SERVICEINFORMATION

ADAPTER CABLE 4.07360.53.0

FOR REPLACING PREDECESSOR VERSIONS WITH THE LATEST EXHAUST BACK PRESSURE SENSORS

View of plug of adapter cable 4.07360.53.0

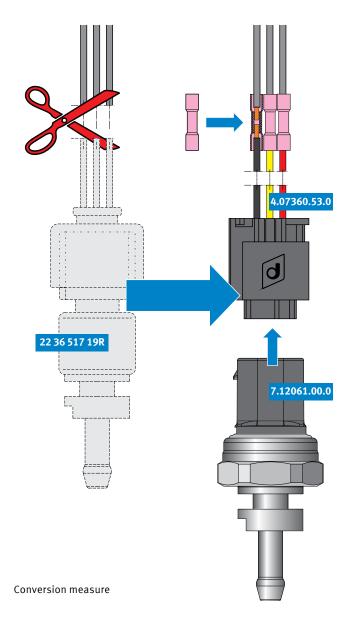
- Cut off the old sensor 223651719R close to the old plug.
- Connect the adapter cable 4.07360.53.0 using the shrink-fit connectors, making sure to observe the pin assignment.

- 01 Ground (red)
- 02 Signal output (yellow)
- 03 Supply voltage (black)
